**HYDE PARK CITY
CITY HALL WELL HOUSE AND TRANSMISSION LINE
ADDENDUM #3**

FEBRUARY 24, 2025

This Addendum #3 covers the following items:

FINAL PRODUCTION WELL PLAN

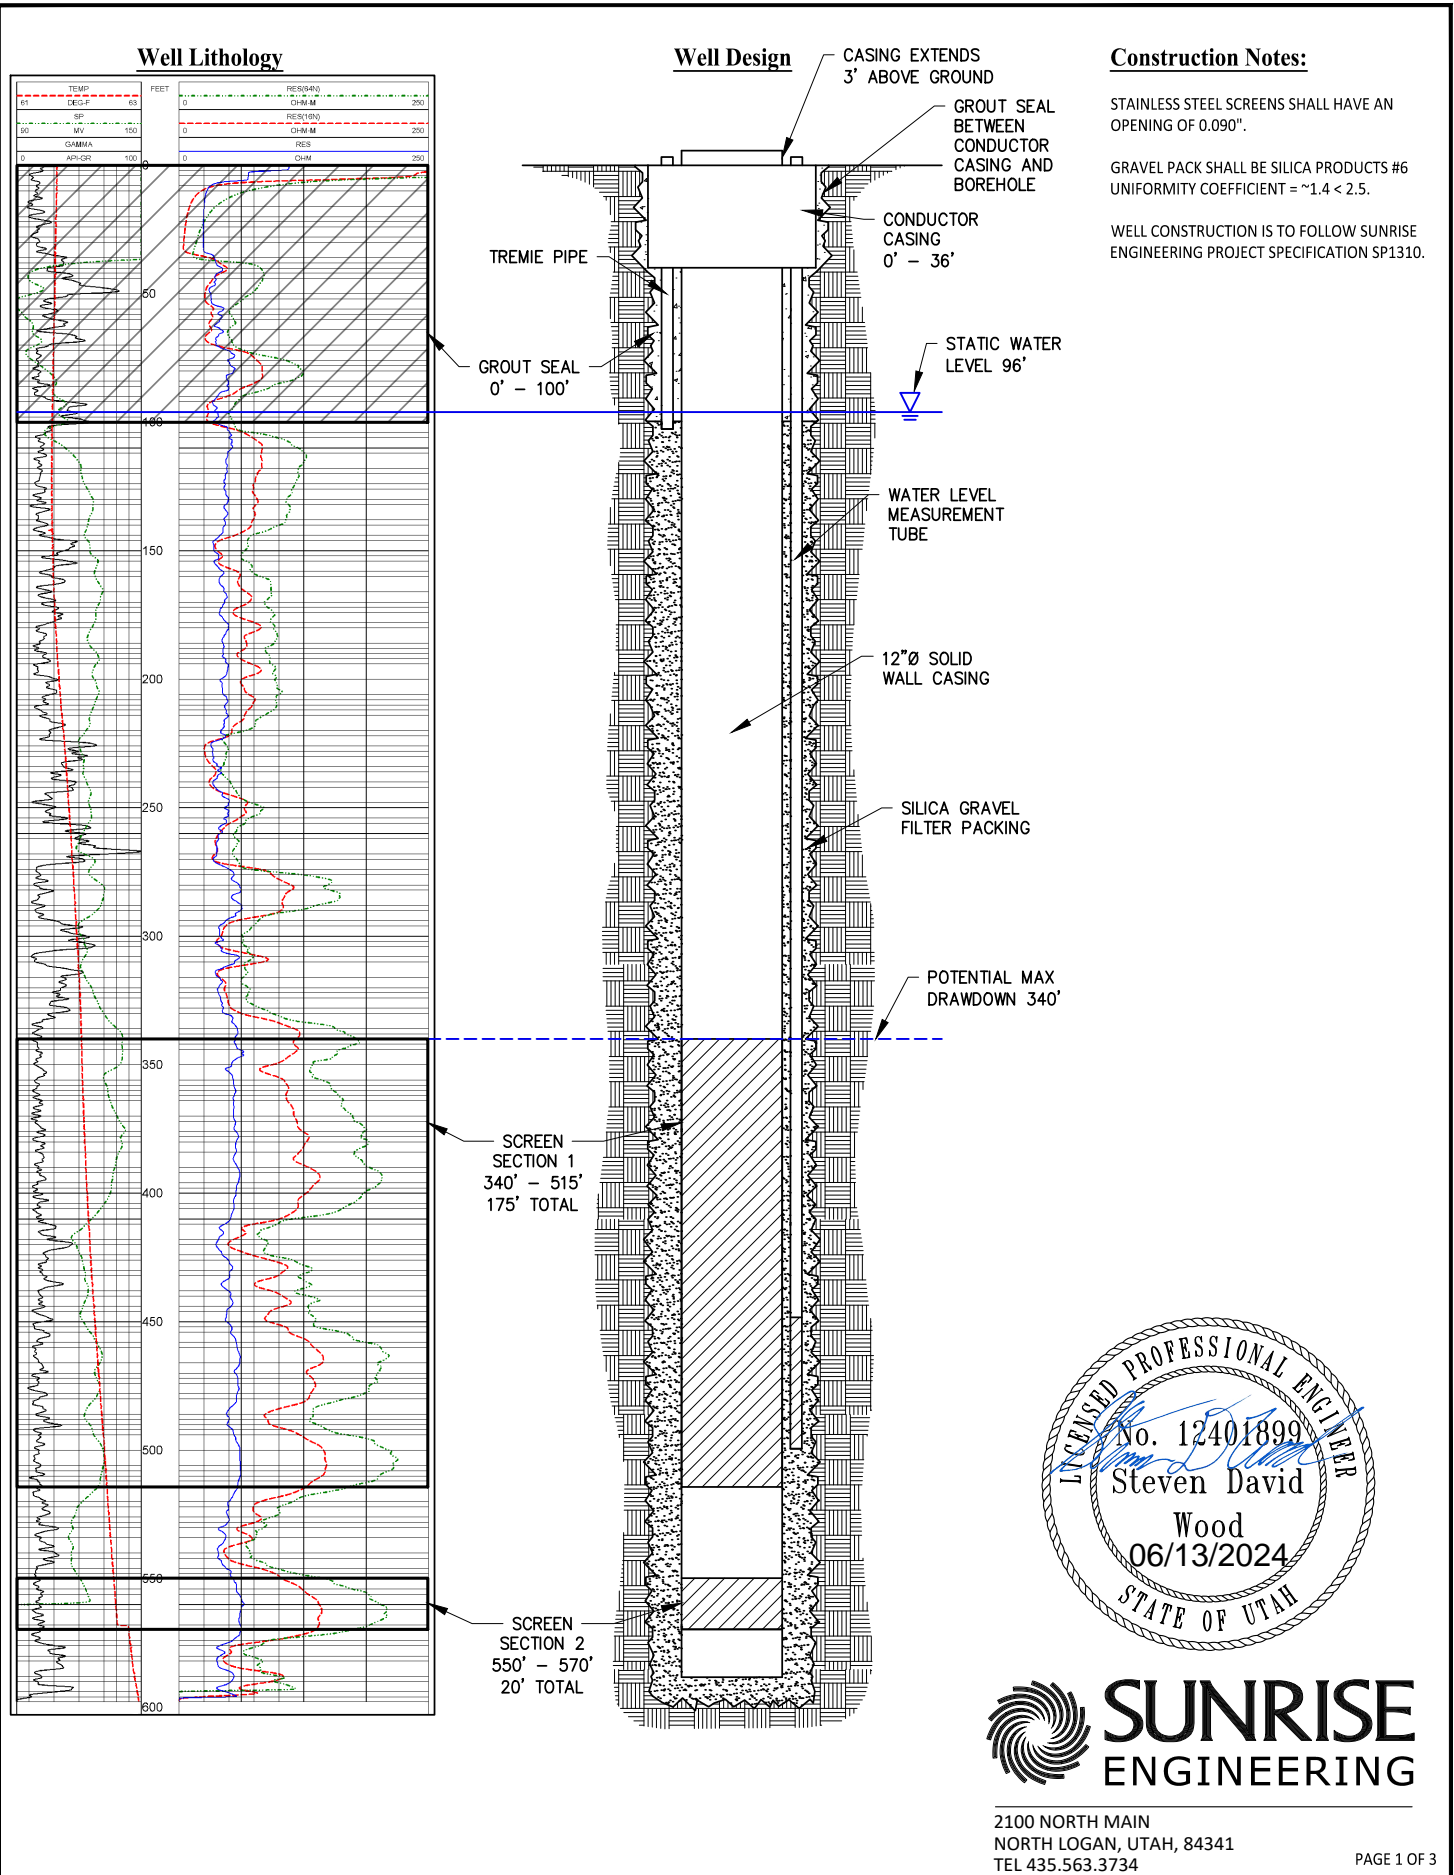
Q: Can an as-constructed drawing for the well in its existing state be provided?

A: Yes. It will be attached to this addendum.

Baker Hughes
WNE1600 Pump 900 SERIES
5 Stage Performance Curve
Sp.Gr.=0.993

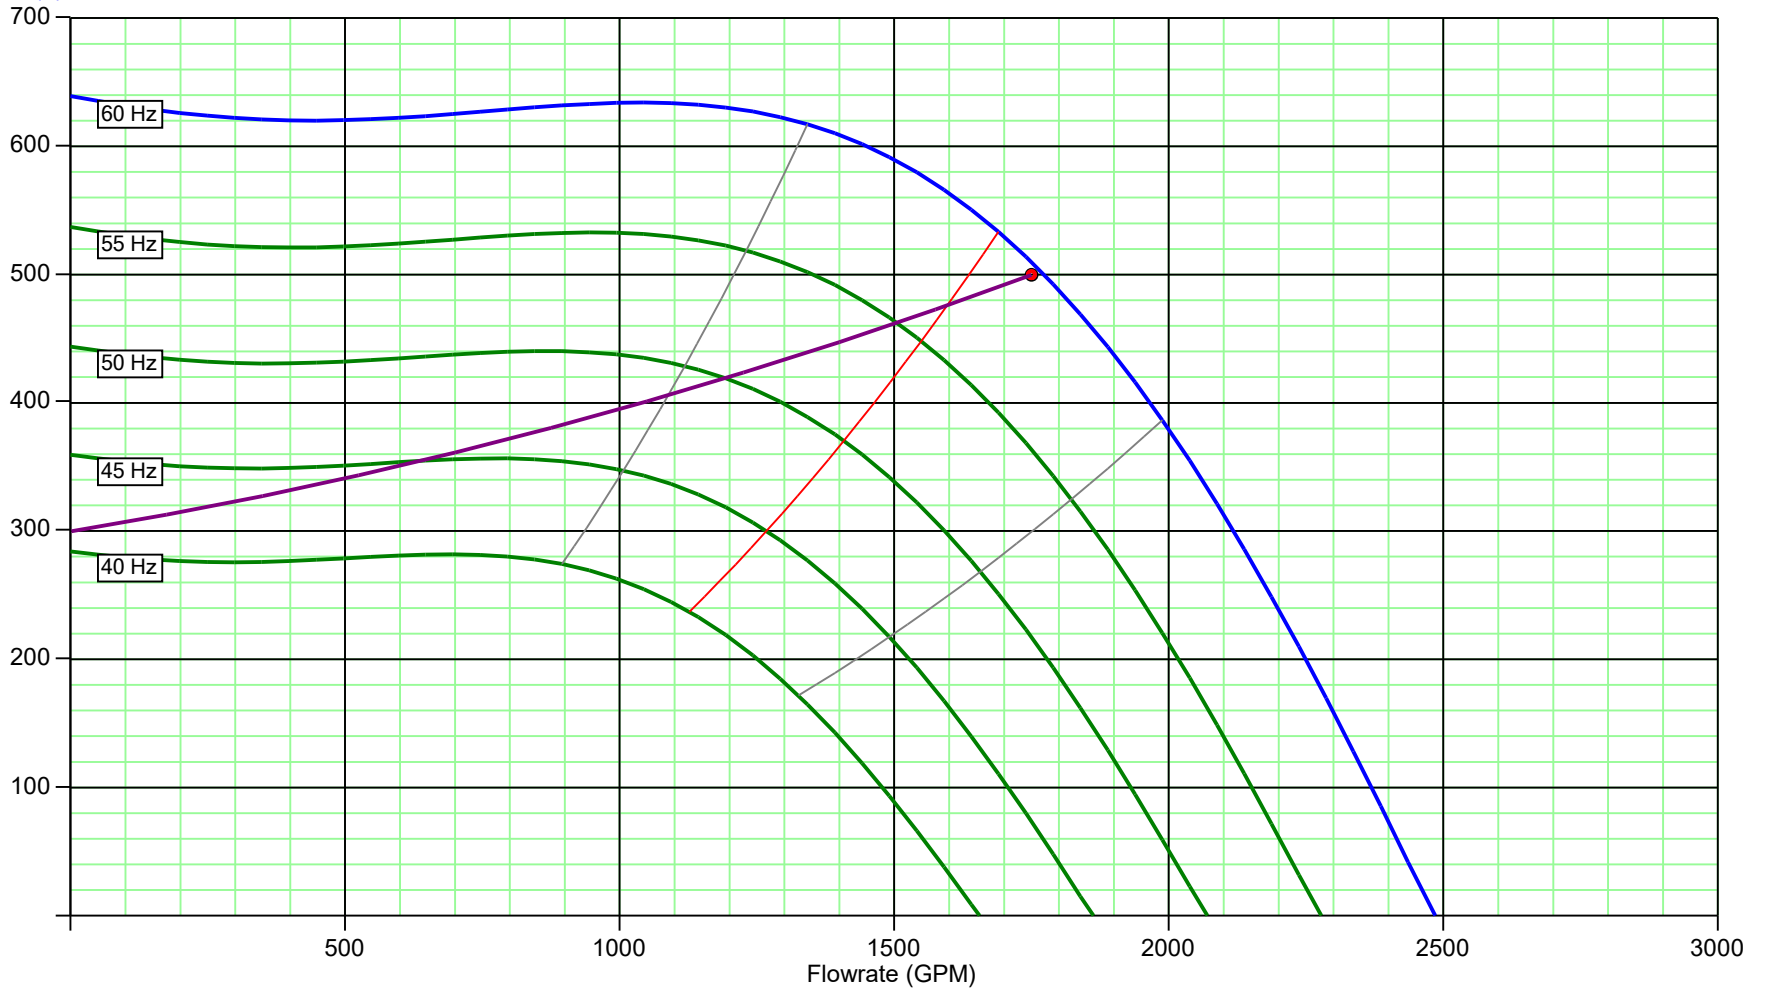
Q: Can the test pump specs from the well drilling be provided

A: The approved submittal from test pumping will be provided.
